January 26, 2010

**Comments on the Validation of the Anhui Wenergy Tongling
1000 MW Ultra-Supercritical Coal-Fired Power Project**

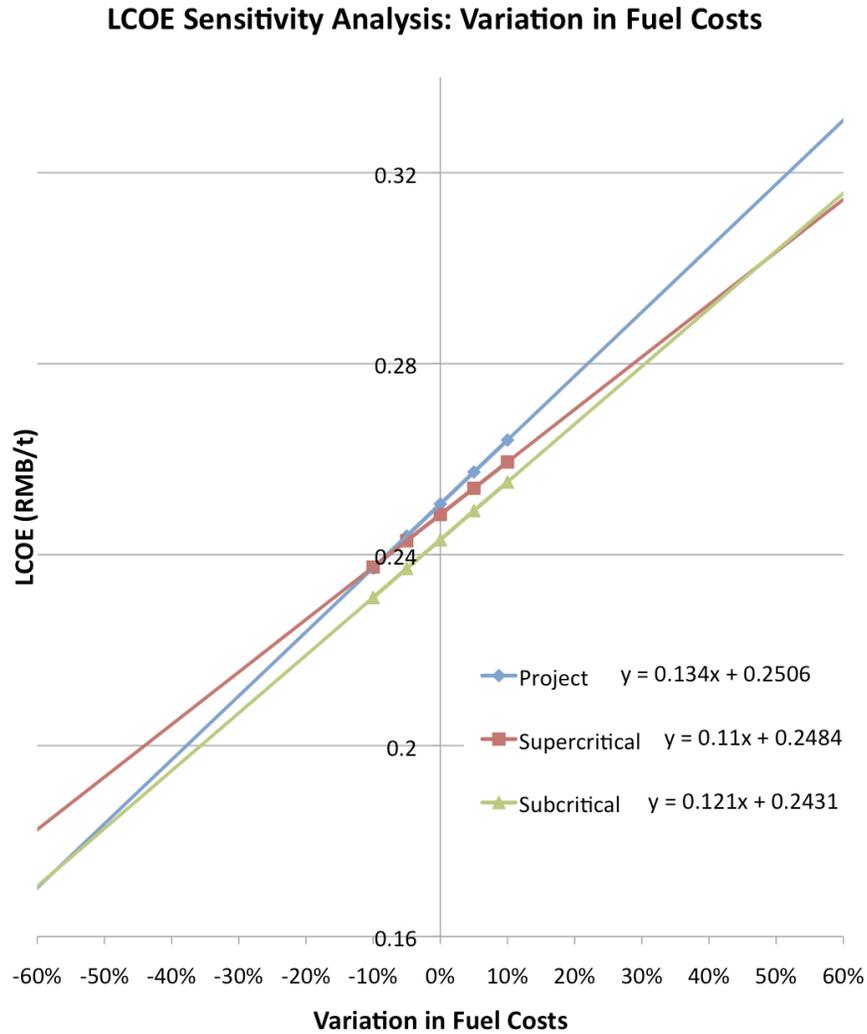
The figure below provides trend lines for each alternative baseline at a plus or minus 60 percent variation in fuel cost, using the data provided in the PDD.

Generally, one would expect more efficient coal plants to become more cost competitive with rising fuel costs. Looking at the figure above, such a relationship is observed between the supercritical and subcritical plants, which converge in their LCOEs when coal prices rise approximately 48 percent above the PDD’s price assumptions (i.e., to around 637 RMB/t). Given recent, observed coal prices, if this analysis is correct, supercritical plants may already be more financially attractive than the subcritical alternative.

Remarkably, the PDD’s data suggest that the Project will actually become *less* financially attractive than either of the other, less efficient alternatives as the price of coal rises. The data point to this result both when looking at the PDD’s narrower sensitivity

analysis (from plus or minus 10 percent) and the broader spectrum provided above (from plus or minus 60 percent). As noted, more efficient plants should become more financially attractive as coal prices rise. The project participants must explain this counterintuitive result.
